State of New Mexico
 Energy, Minerals and Natural Resources

WELL API NO. 30-025-42392
5. Indicate Type of Lease STATE <input checked="" type="checkbox"/> FEE <input type="checkbox"/>
6. State Oil & Gas Lease No.
7. Lease Name or Unit Agreement Name Encore M State
8. Well Number 18
9. OGRID Number 370080
10. Pool name or Wildcat: WC-025 G-04 S2237201;Devonian

Breitburn Operating LP respectfully requests to amend the Application for Permit to Drill the Encore M State 18 as follows:

BREITBURN - New Mexico
ELLENBURGER VERTICAL WELL W/ 3 Casing Strings
M STATE 18 - WELLBORE DIAGRAM

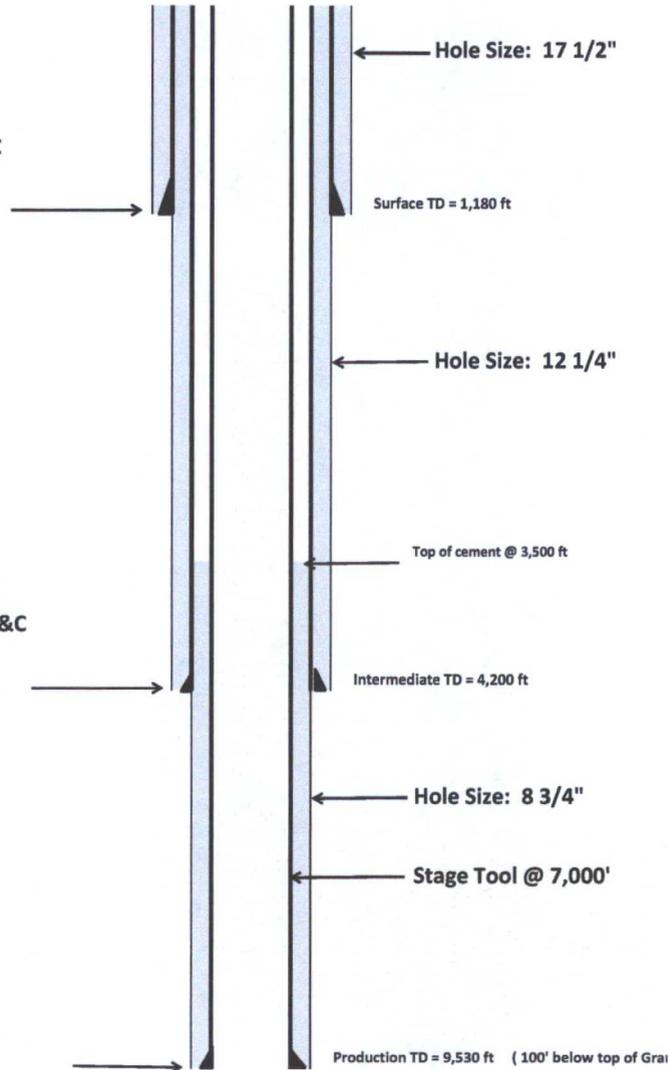
Change proposed depth to 10,000 ft.

Change proposed casing program as follows;

Surface: Hole size 17 1/2", casing size 13 3/8". 54.5#, K-55, BT&C setting depth 1,180 ft.
 Intermediate: Hole size 12 1/4", casing size 9 5/8", 40# SD, HCK-55, LT&C setting depth 4,200 ft.
 Production: Hole size 8 3/4", casing size 5 1/2", 20#, L-80, LT&C setting depth 9,530 ft.

Working pressure on BOP is 5000 psi.
